HUMAN FACTORS DESIGN REVIEW

LIMERICK 1 & 2

CONTROL ROOM

SUMMARY REPORT

FIGURE 1. CONTROL ROOM ARRANGEMENT

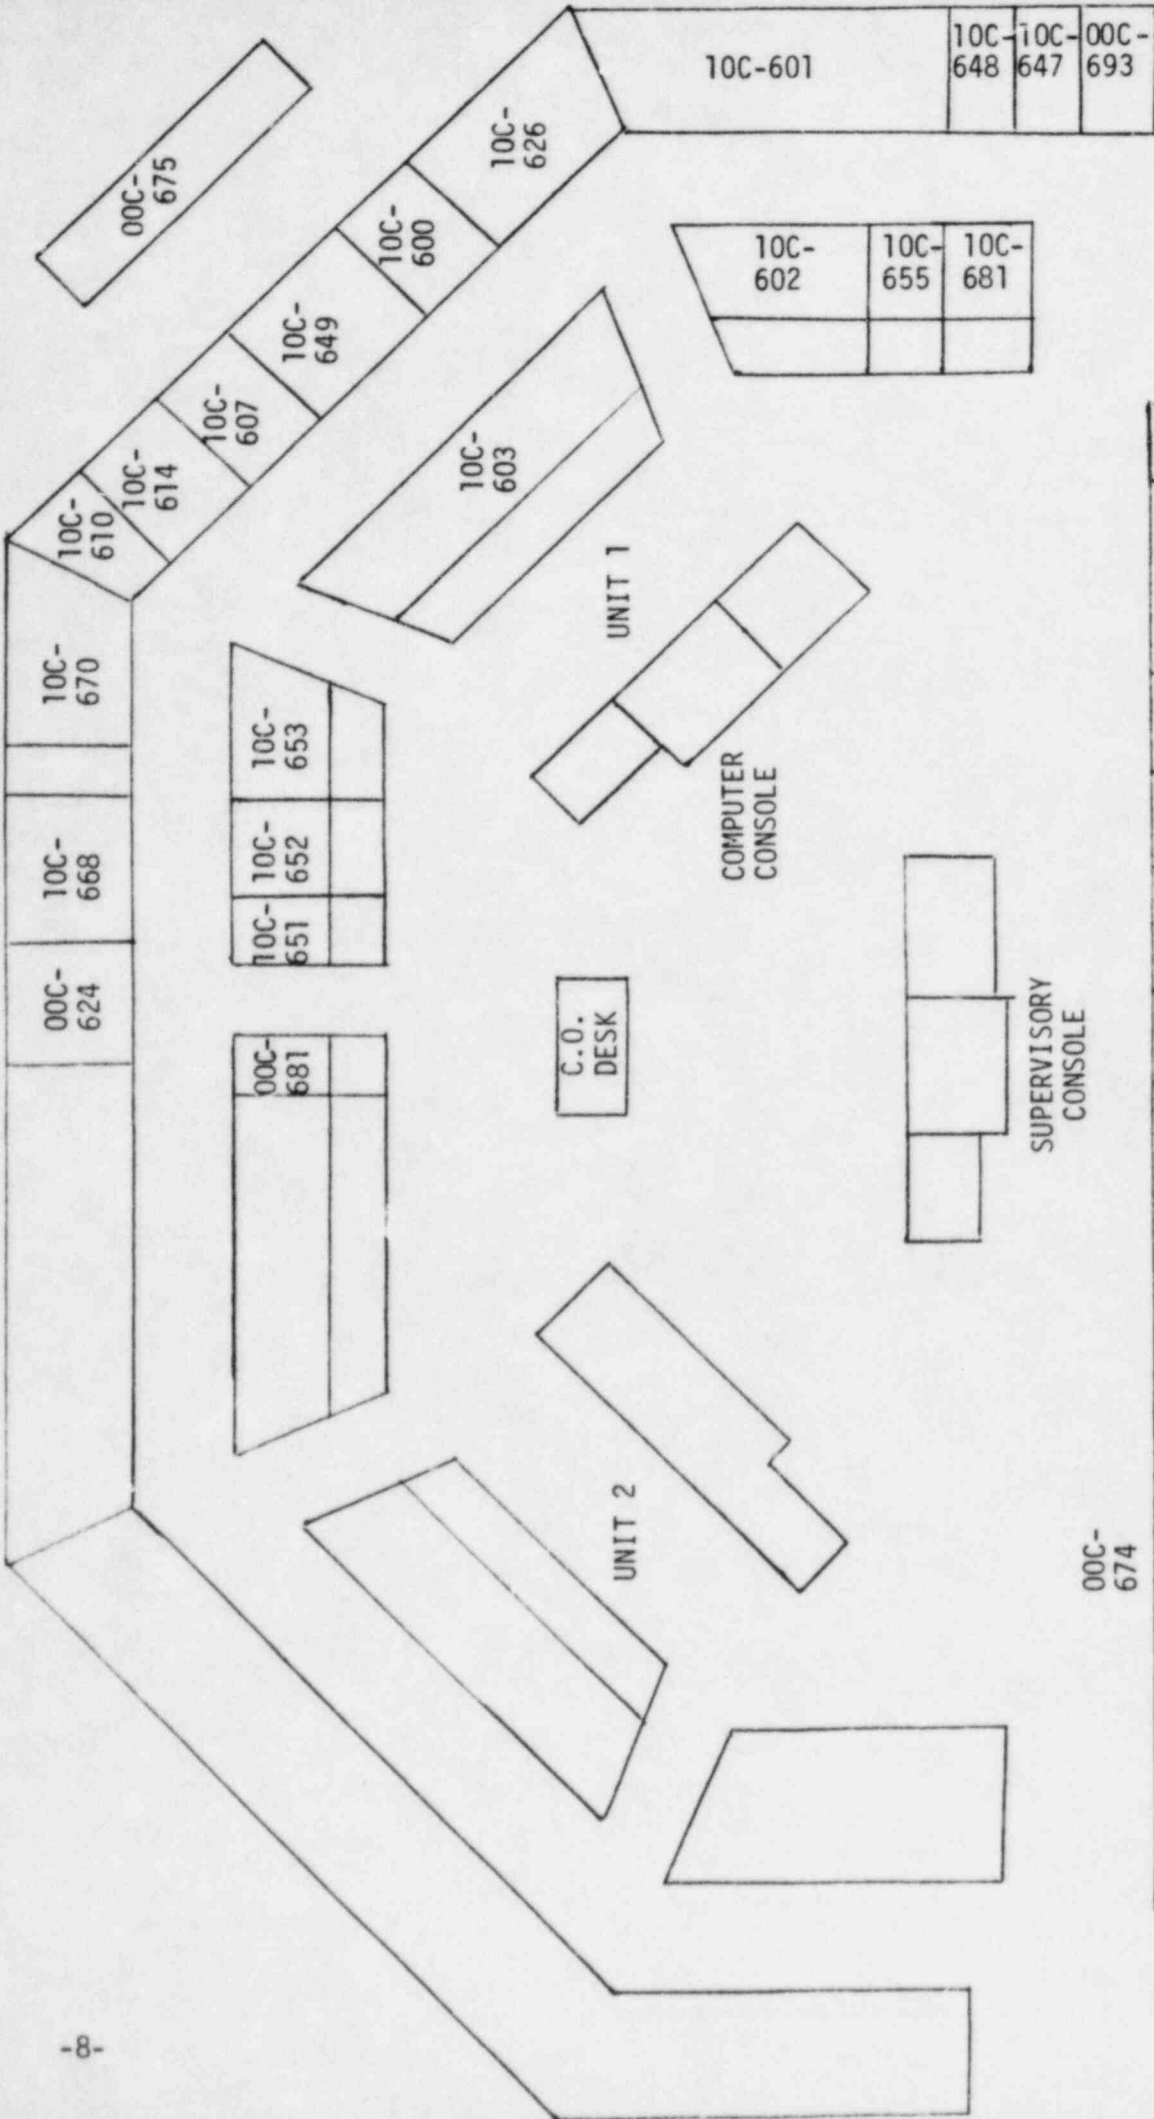
While overall panel dimensions are in close compliance with checklist standards, controls and indicators were often found mounted above and below recommended heights on most vertical panels. Indicators were found as high as 92" and as low as 22", and controls were found as high as 80" and as low as 20". (The recommended range for vertical panel indicators is 48" to 68"; for controls, 42" to 60".) Also, all annunciators in the primary operating area exceed the maximum recommended height of 88" (top row is 118" high).

Two panels, OOC-681 and OOC-667, were noted which, besides the use of enhancement techniques previously mentioned, could benefit from the rearrangement of components into functional and easily recognizable systems. The Heating and Ventilating Console, OOC-681, is rather disorganized and, for the most part, mirror-imaged. The ESW control panel, OOC-667, was noted by operators interviewed to be very confusing to operate.

| 3. The path to and view of vertical panels located behind the benchboards is obstructed by the benchboards. This is especially of concern for the ECCS panels. In addition, the view of the ESW panel is somewhat obstructed. (A7.1, A7.2) | 9 |
